Design Exception #6

Slopes for the Recreational Trail

**I-70 West Vail Pass Safety and
Operations Improvements**

DESIGN EXCEPTIONS MEETING
AUGUST 23, 2021

CAP 2
Trail Tie In

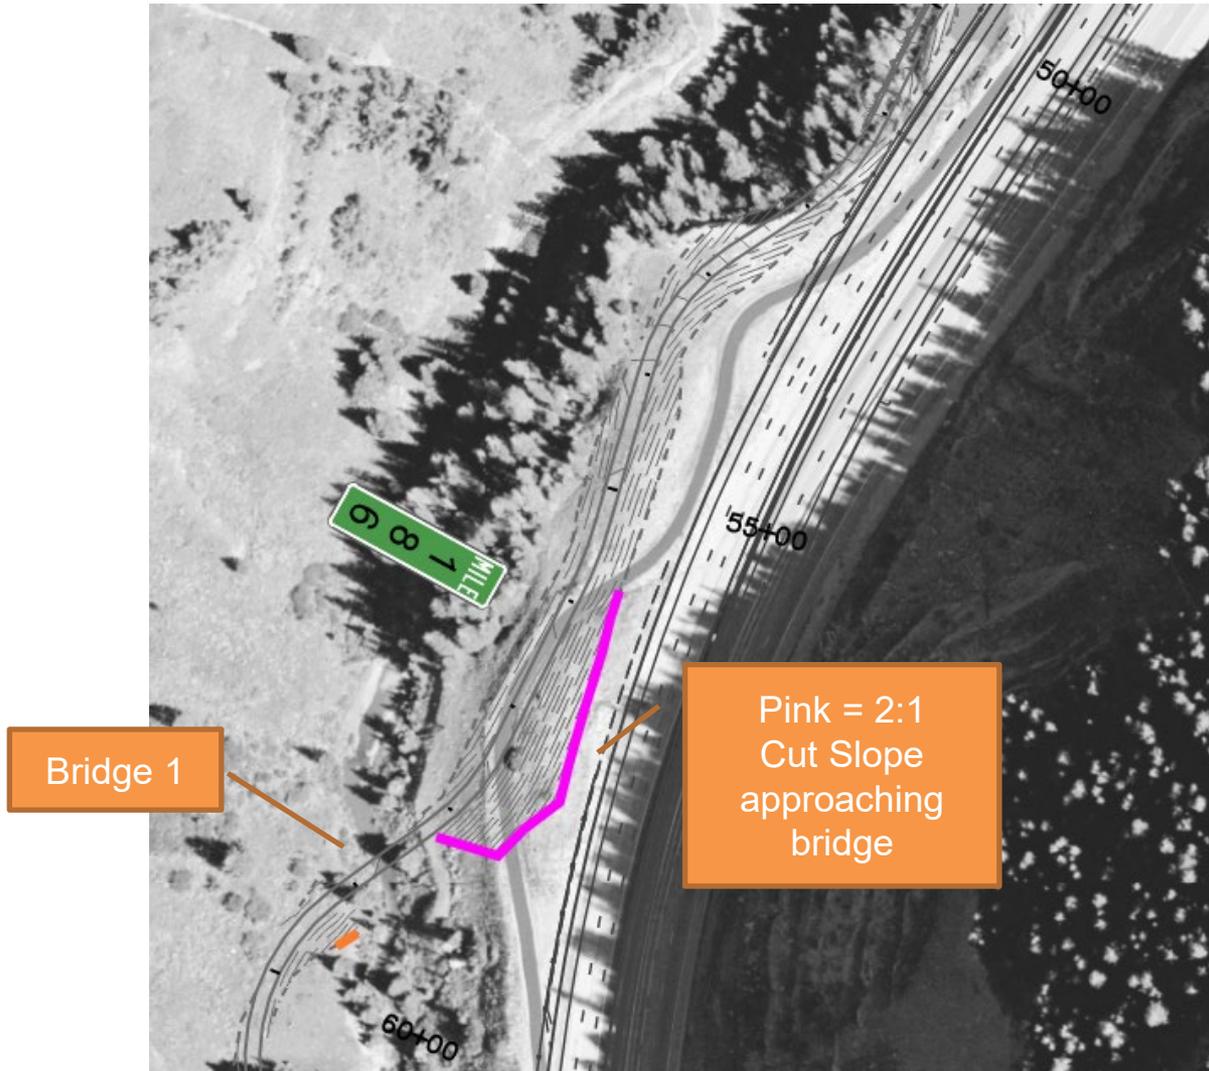
Pink = 2:1
Cut Slope

Orange = 2:1
Fill Slope

Recreation Trail Design Exceptions

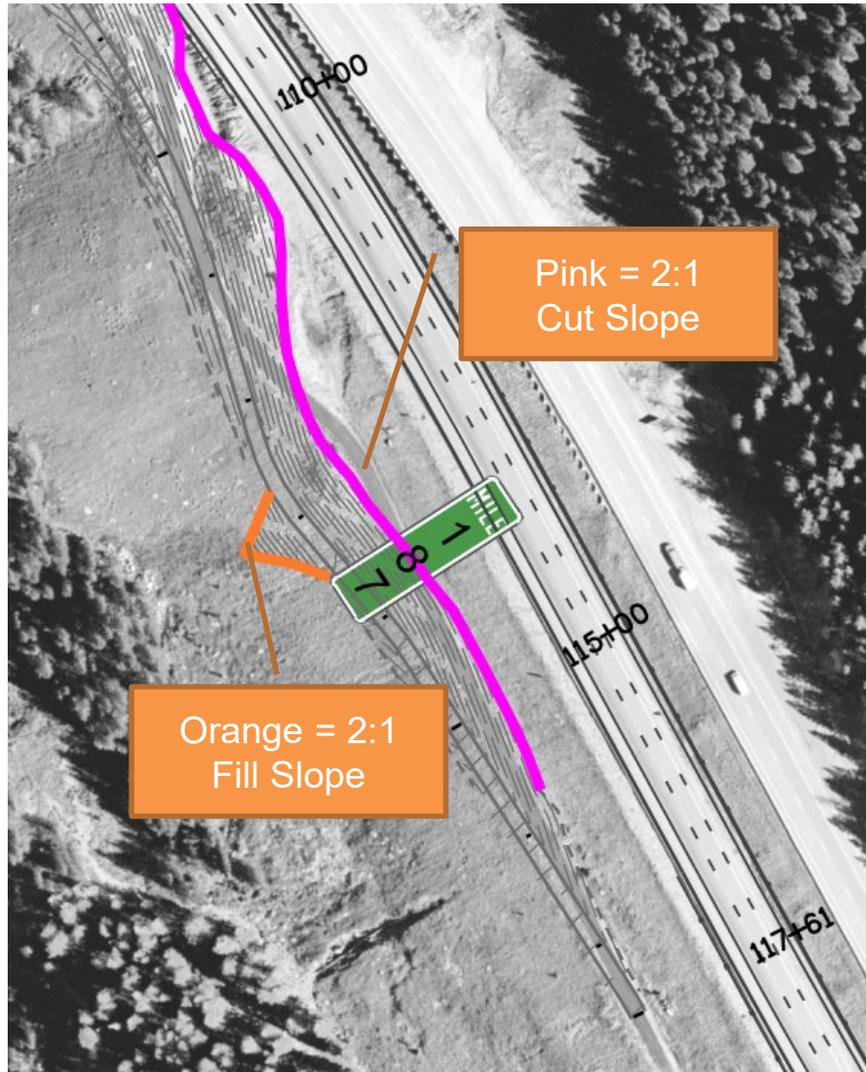
Pink = 2:1
Cut Slope –
approach to wall
